E3.I Cayenne DME P242100 – Fuel Tank Isolation Valve for Tank Ventilation System - Stuck Open

Bulletin #: 2412.2

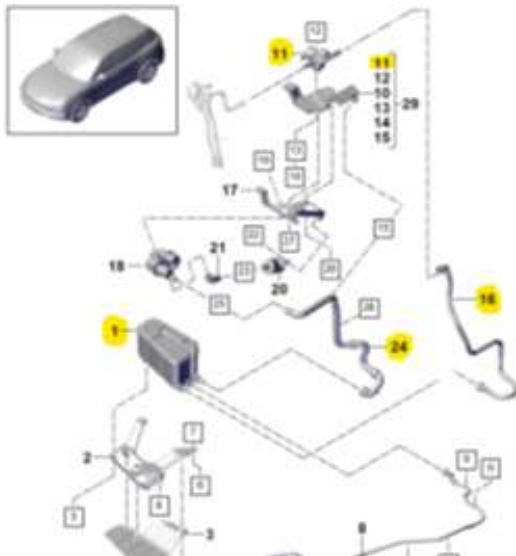
Please replace these four components shown in yellow below:

1)	PAB 201 801 C	Evaporative Emission Canister
11)	PAD 201 559	Pressure Regulator
16)	PAB 201 183	Breather Line
24)	PAB 201 999	Vent Hose
